**RIVERSIDE COUNTY HEALTH DEPARTMENT**

**CITY OF RIVERSIDE, CALIFORNIA**  
**DEPARTMENT OF PUBLIC WORKS**  
**TEMPORARY**  
**SEEPAGE PITS**  
**TRACT 2121**  
APPROVED BY [Signature]  
DIRECTOR OF PUBLIC WORKS  
DATE 12-7-60  
NO. 5-263  
SHEET 1 OF 1

**PLAN**  
Scale = 1" = 10'

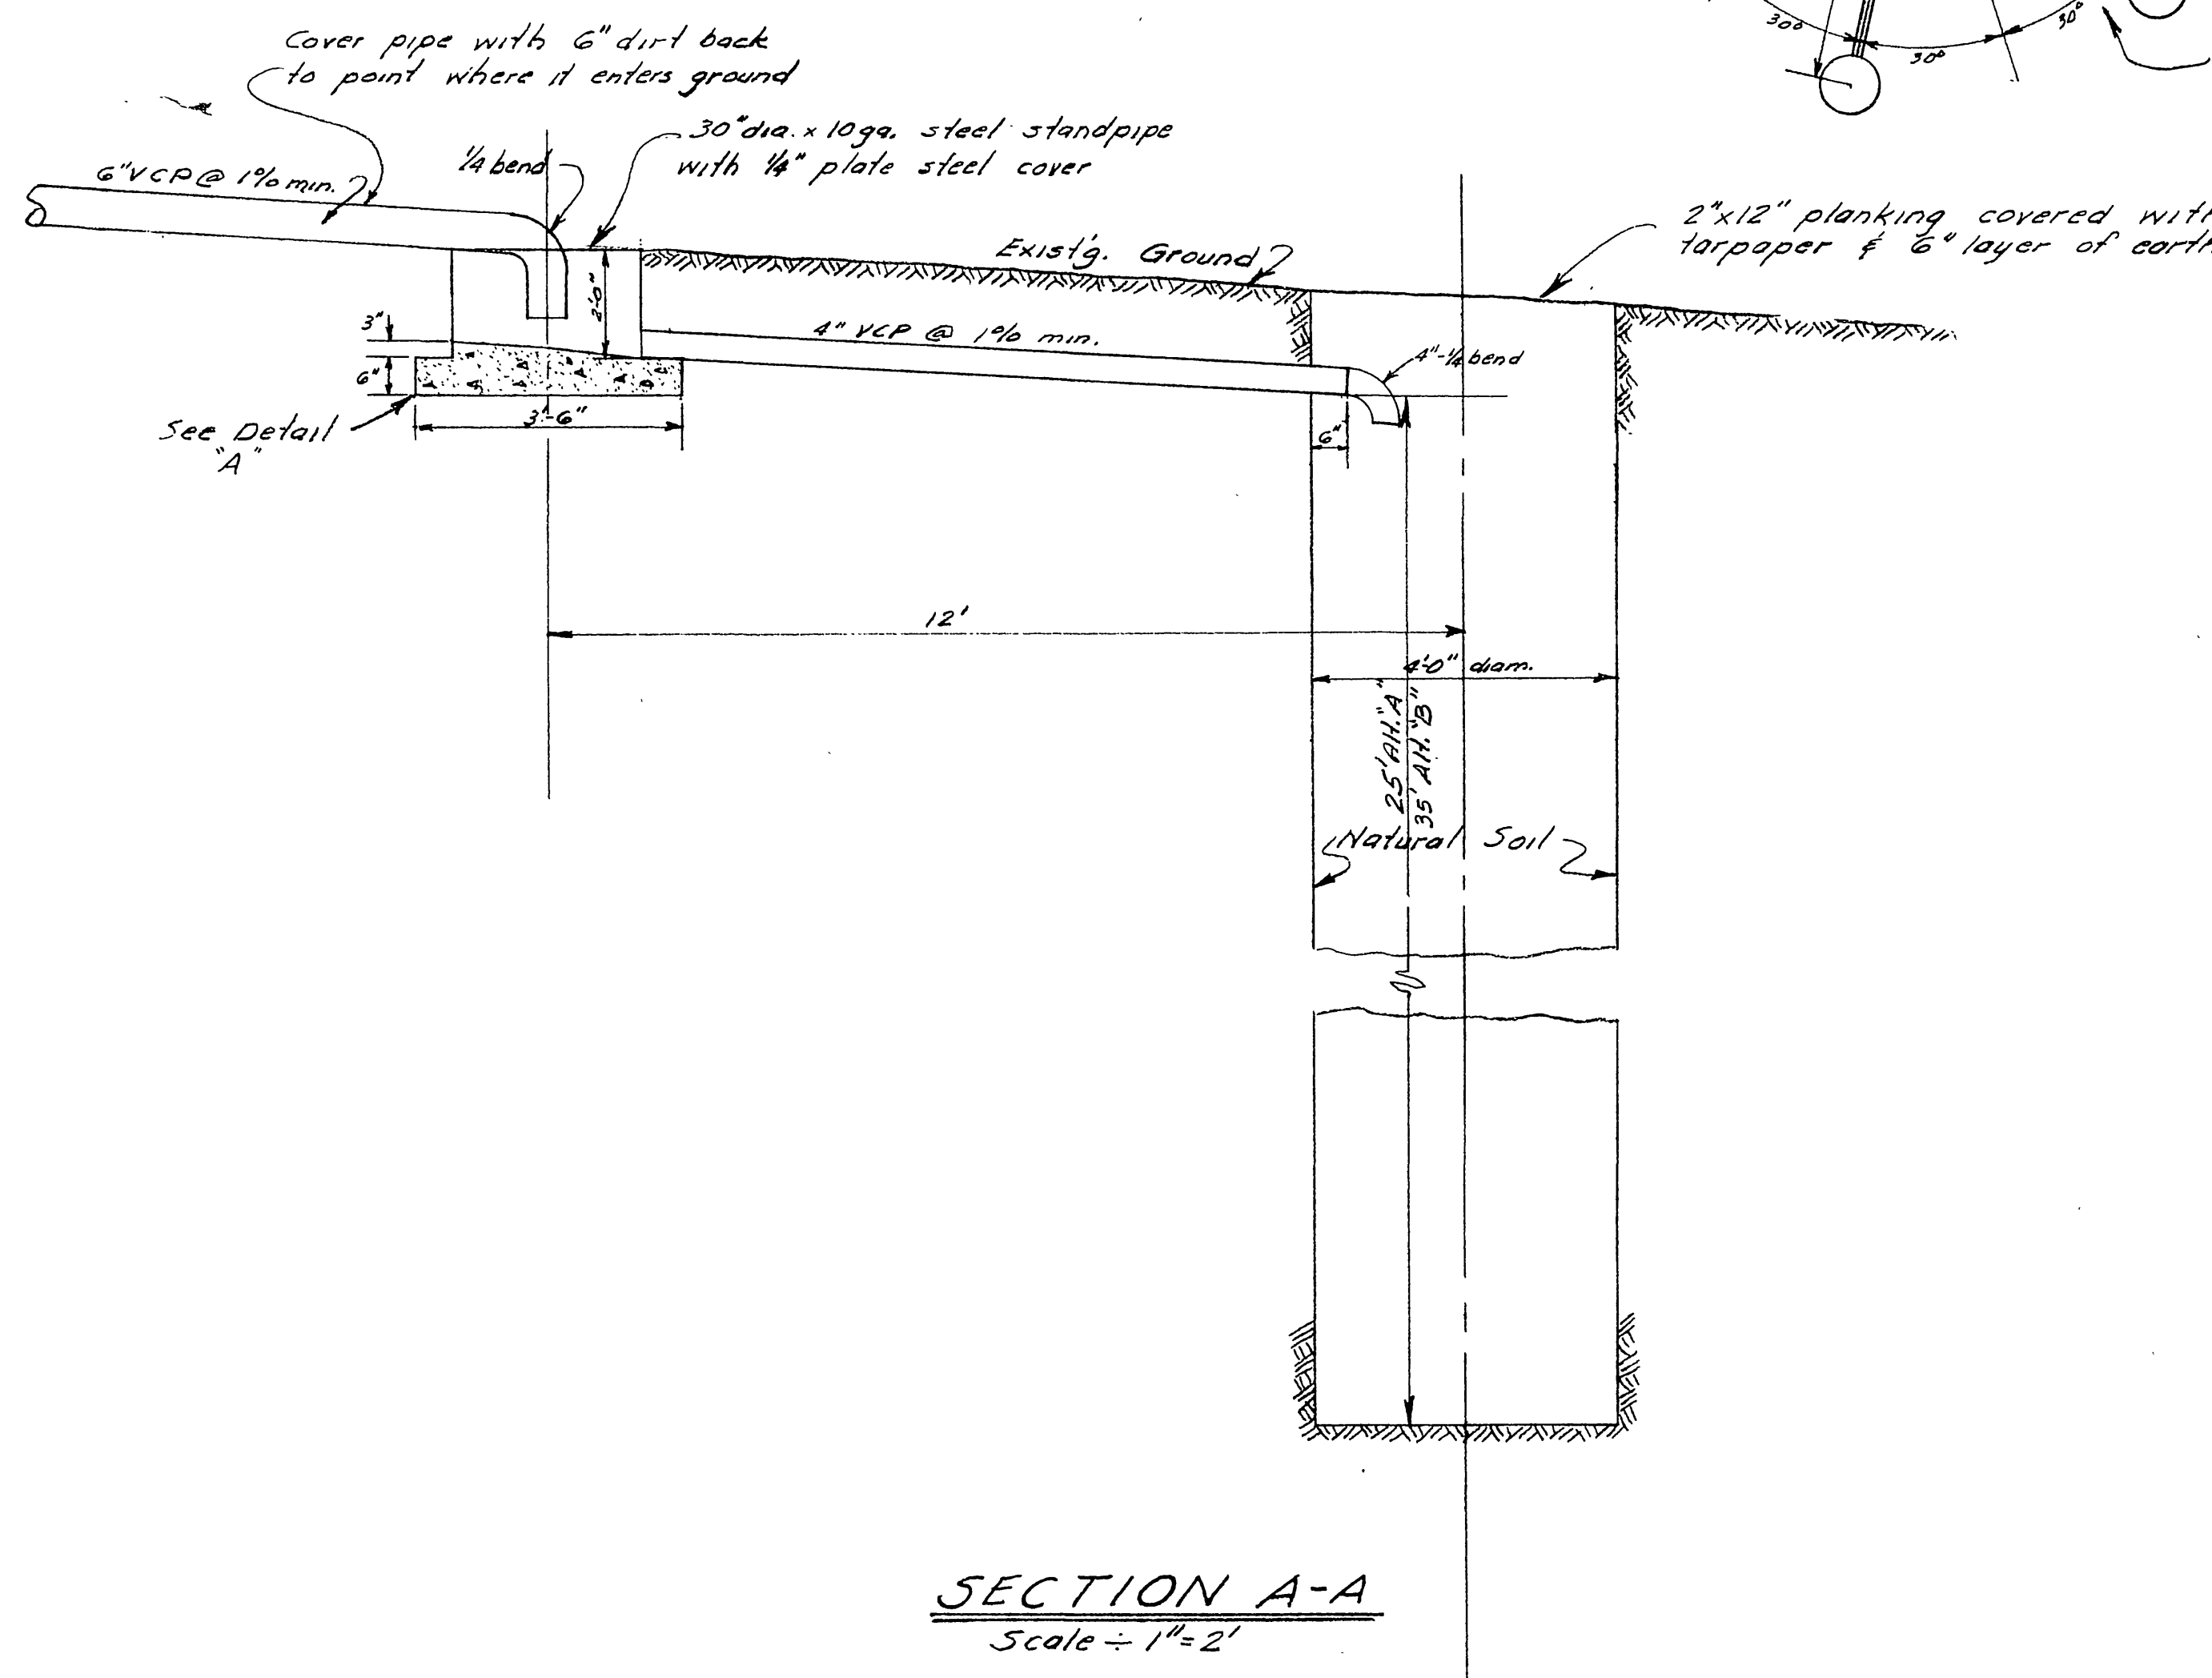
**"AS BUILT" NOTES**

- 1- Wye to be installed at Sta. 3160 of F.L. Elev. 1206.50 & 6" pipe run 100' to enter standpipe of Elev. 1287.90. Ground Elev. at standpipe = 1287.90.
- 2- Wye and standpipe locations & elevations determined at meeting in field Jan. 5, 1961, by C. Wapner, Reber, E. Webb & R. Cowling.

**ALTERNATE "B"**

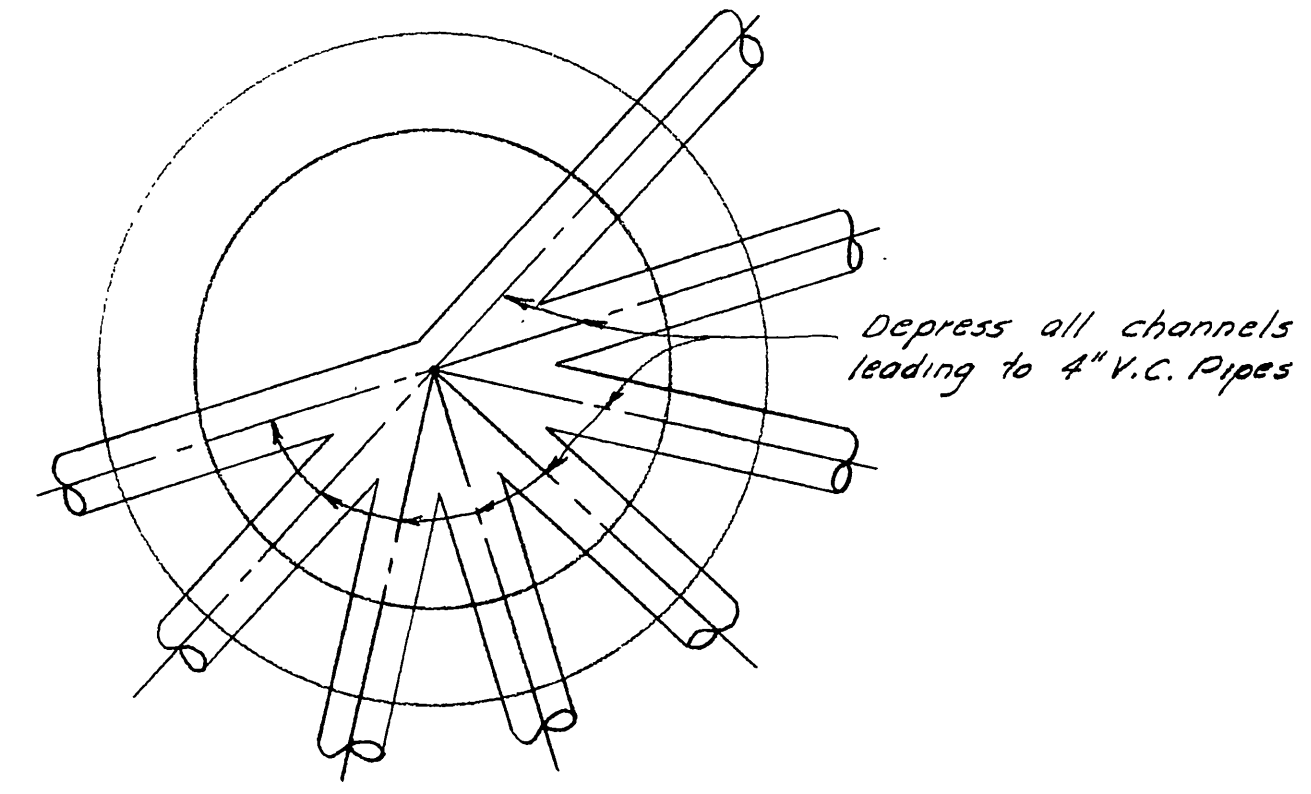
Alternate "B" Approval - By 1-13-61  
Date [Signature]
